P-cup and swivel assembly upgrade

Document number: 709-00225A-A

Product	FCO priority
Magnus VLF with Autoloader.	Next Failure

Machines affected Upgrade machines MT030 and before.

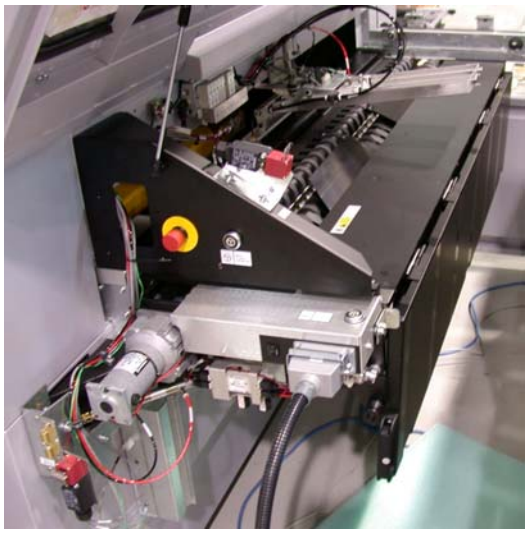
The P-cups do not have enough lift capacity to lift all plates. Also, the P-cup swivel bar is not manufactured to drawing, so it reduces the swivel capability of the P-cups.

Change the P-cups to more powerful ones and replace the swivel bar with a new version to ensure the parts meet specifications.
